HQDFM Design for Manufacture(DFM) Report

File name: 2024-07-13

Time: 2024-07-13Layer count:2 PCB Thickness: 1.60 Quantity: 5 mm

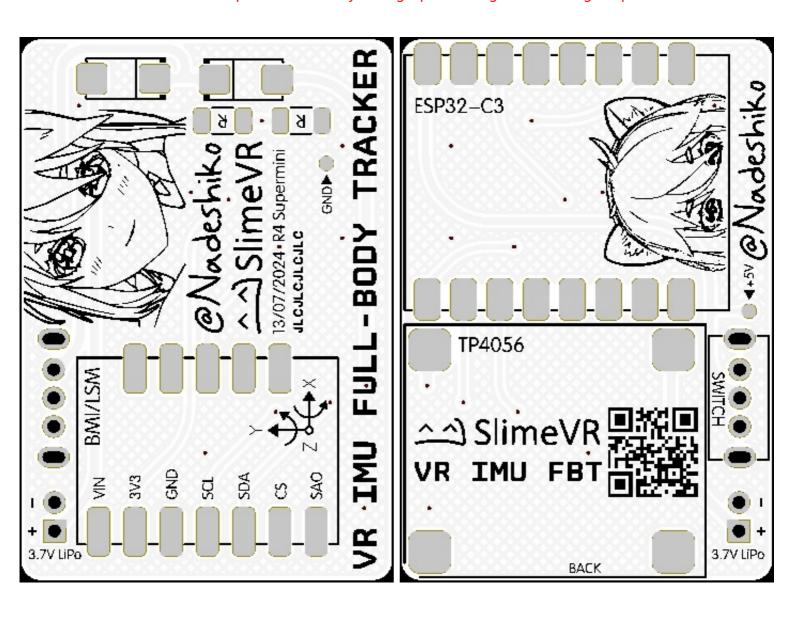
The file size is small, which can affect the surface mount assembly process. It is recommended to have a size larger than 7*7cm. You can optimize the size by adding a process edge or increasing the panelization.
